CITY OF ALBUQUERQUE

**RE: Guardian Storage- Juan Tabo
4909 Juan Tabo NE
Revised Conceptual Grading Plan Stamp Date: 1/9/20
Drainage Plan Stamp Date: 12/20/19
Hydrology File: F21D081**

Based on the submittal received on 1/13/20, the Conceptual Grading and Drainage Plan is re-approved for Site Plan for Building Permit.

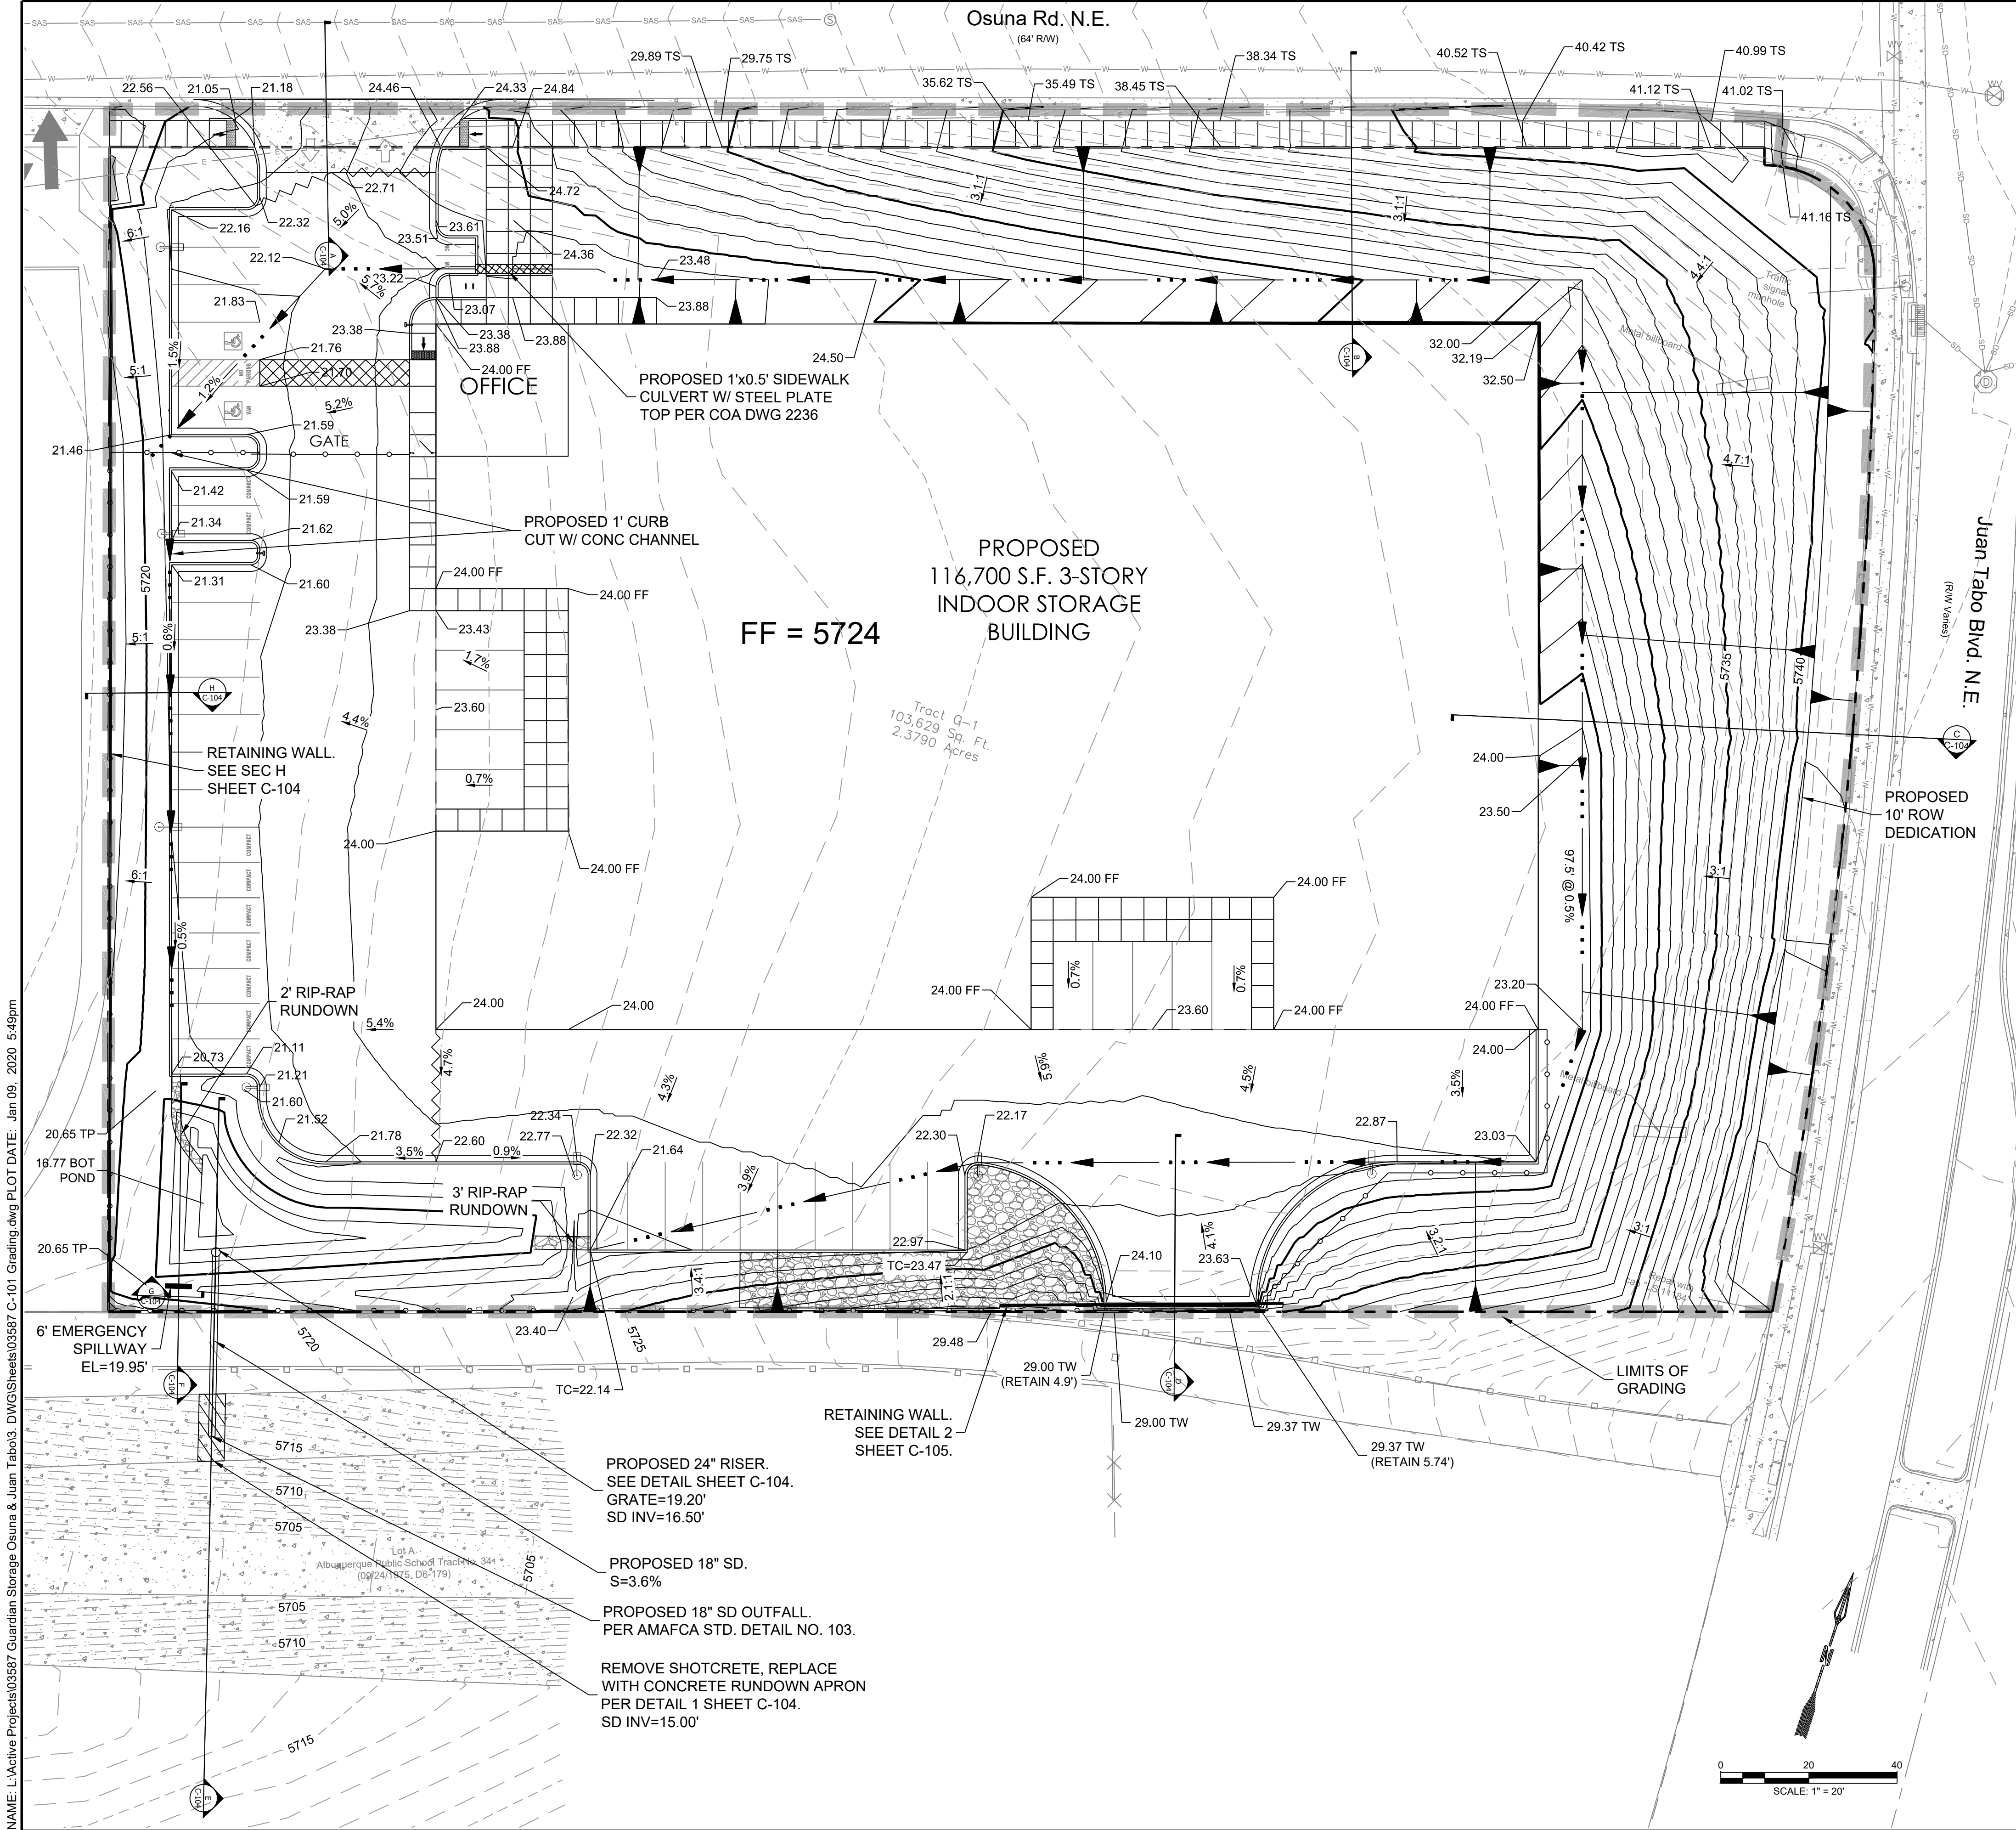
1. Remove all "Conceptual" markings.
2. As a reminder, if the project total area of disturbance (including the staging area and any work within the adjacent Right-of-Way) is 1 acre or more, then an Erosion and Sediment Control (ESC) Plan and Owner's certified Notice of Intent (NOI) is required to be submitted to the Stormwater Quality Engineer (Doug Hughes, PE, jhughes@cabq.gov, 924-3420) 14 days prior to any earth disturbance.
3. Provide hydraulic calculations for the proposed storm drain outfall, calculated along the Energy Grade Line; include both the HGL and EGLs. The 10-yr water surface in Bear Canyon Arroyo may be used as the control surface for the storm drain HGL calculations.
4. Additional comments may be provided at Building Permit, based on the outcome of the above remarks and level of detail shown on plans.
